No.	2021-P154	
	To	Board of Directors	
For	DECISION	Date	2021-06-23

PSPC Energy Services Acquisition Program (ESAP) – Federal Land Use and Design Approval (FLUDA) for Final Developed Design of Level 3 project components: Cliff Plant, Tunney's Pasture Plant and River Pump Station

To seek approval for the Final Developed Design for key ESAP project components requiring Level 3 FLUDA review, including:

Triodetic curtain/  
Rideau Triodétique

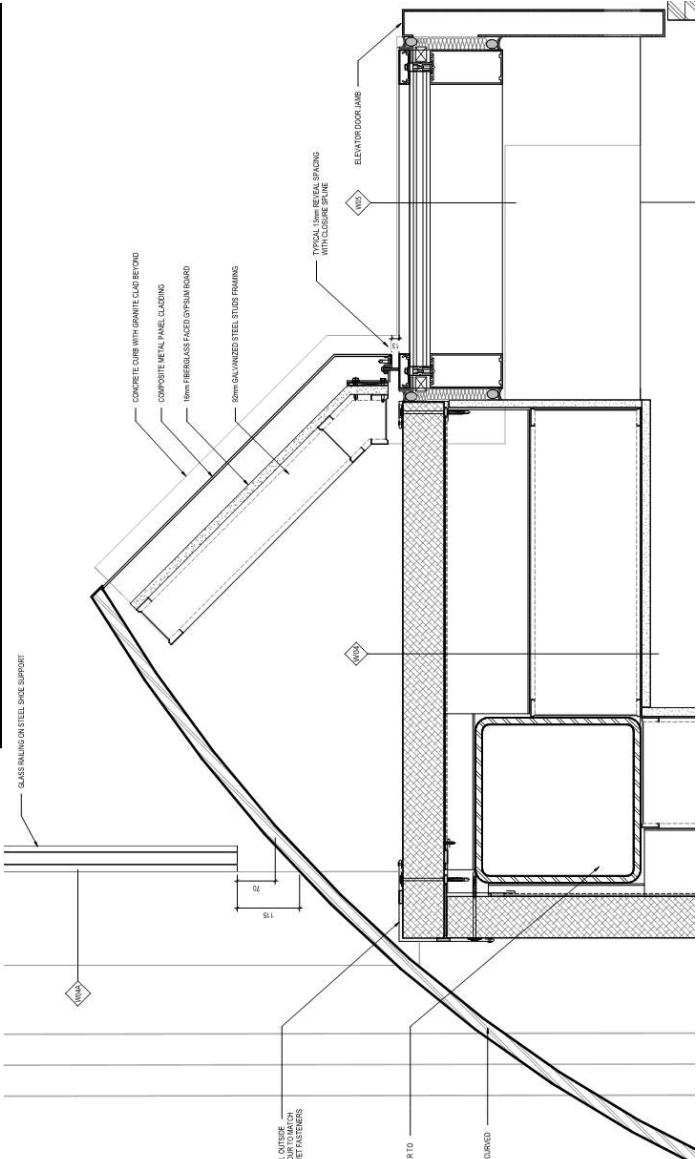
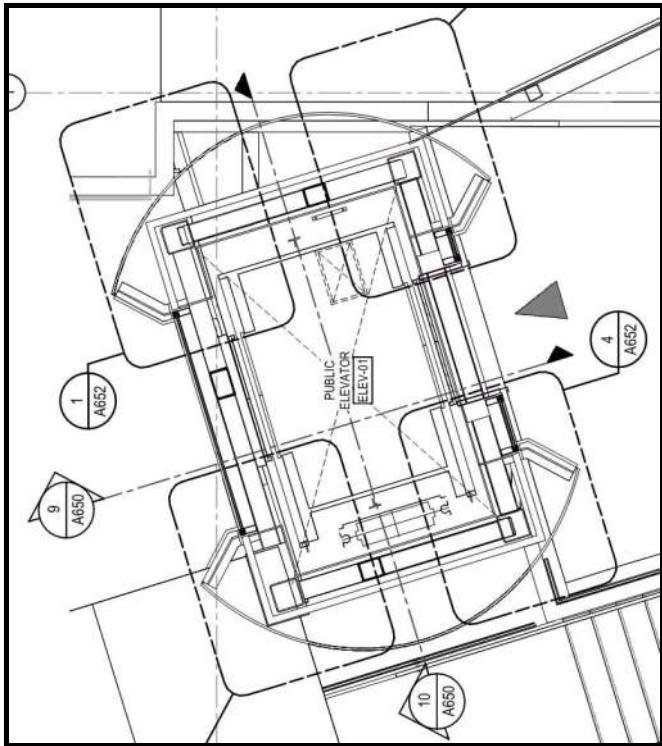
- More detail is needed regarding the plant's architectural screen (drapery) to ensure the design resolution results in long-term viability and durability.

- Given the visual prominence of the screen, plant material could be integrated (e.g., climbing vines at the base of the plant) to improve views. The screen should be porous to achieve the desired visual effect.

- Vegetation to soften the screen's appearance should be considered.

- Resolution of the design of the mesh curtain, colour and opaqueness.
- Resolution of the handrail design on the 'upper plateau'.
- Final landscape design of the interface between the Plant and the Ottawa River Pathway, particularly focusing on the retaining wall(s) and landscaping.
- Resolution of the final material finish on the cladding of the two exhaust stacks and required bird fritting.
- Final approval of the cladding for the Cliff Plant.
- Testing of exterior lighting.

## Stack Details/Détails des Piles

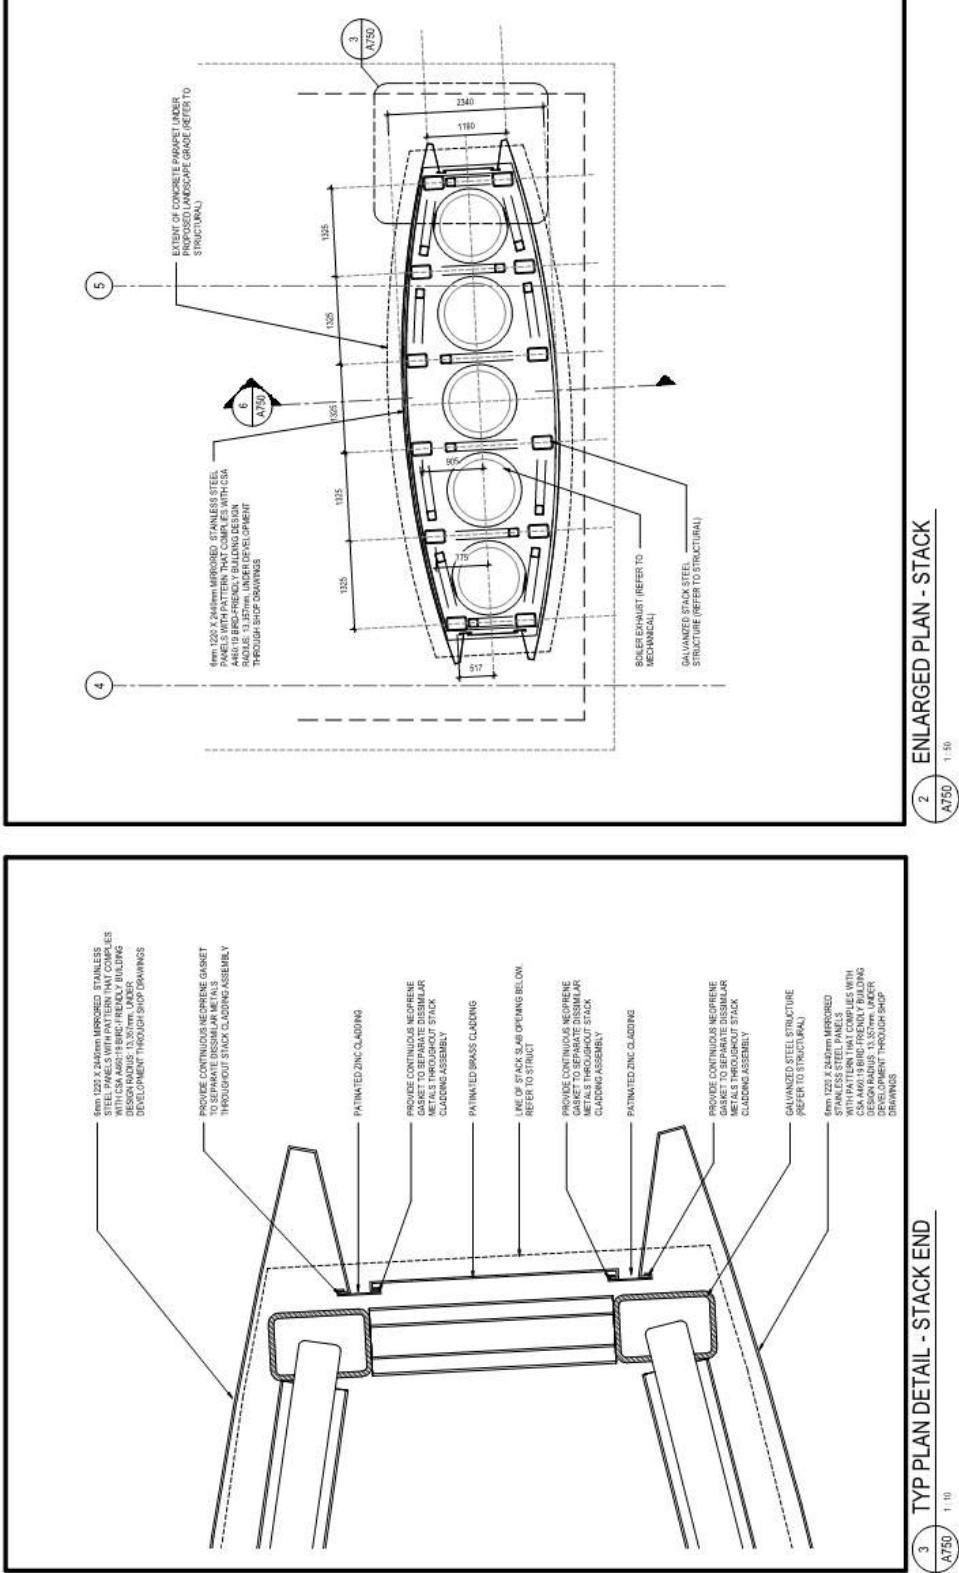
- A treatment to reduce the risk of reflected solar glare from the chimneys' mirrored steel material should be considered.
- The landscape approach at base of the plant should incorporate native planting to screen the service area.

- The width reduction from 11 metres to 7 metres is appreciated.
- Some concerns were expressed about the shiny material which could be a hazard for birds. It should be a more discreet and contemporary finish and have a bird-friendly design.
- Solar panels could be considered on stalks to support night lighting (symbolic value, future of energy).

- Continuing to refine and perfect the design of the mesh curtain screen at Cliff Plant.
- Reducing the width of the exhaust stacks at Cliff Plant from 11 metres to 7.5 metres.
